City of Portland, Maine – Building or Use Permit Application 389 Congress Street, 04101, Tel: (207) 874-8703, FAX: 874-8716

BUILDING PERMIT REPORT

DATE: 17 July 2000 ADDRESS: 45 Deering St. CBL: 047-B-016

REASON FOR PERMIT: Remove & replace deck. Deck will be larger.

New Deck

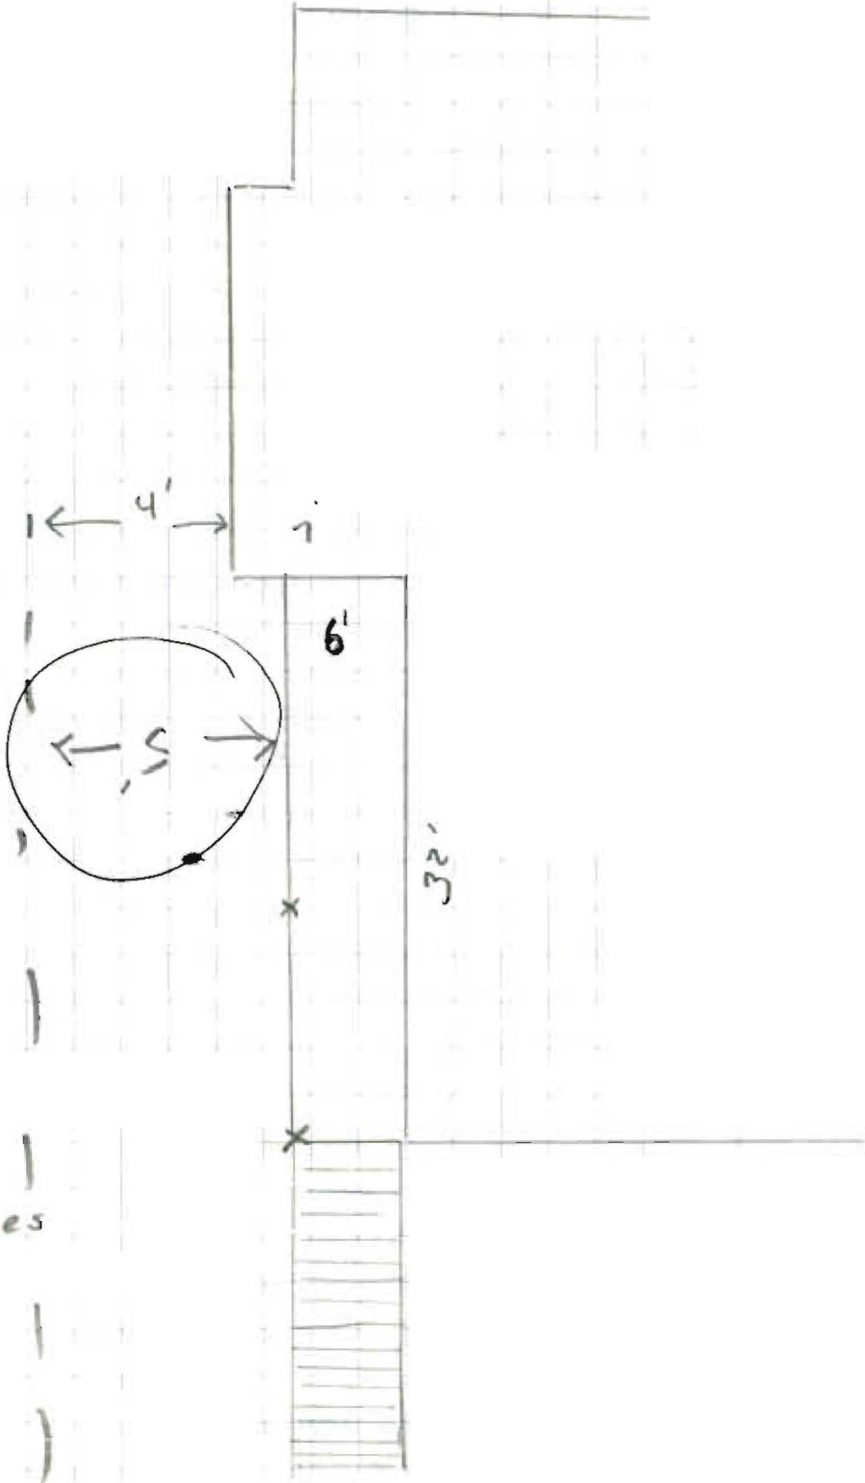
to be no closer than 5' to the side property

shall be no less
than 5' -
OK per 1A-433
S

Railings ~~36"~~^{42"} hgt - 3 1/4" wide *see attachment*
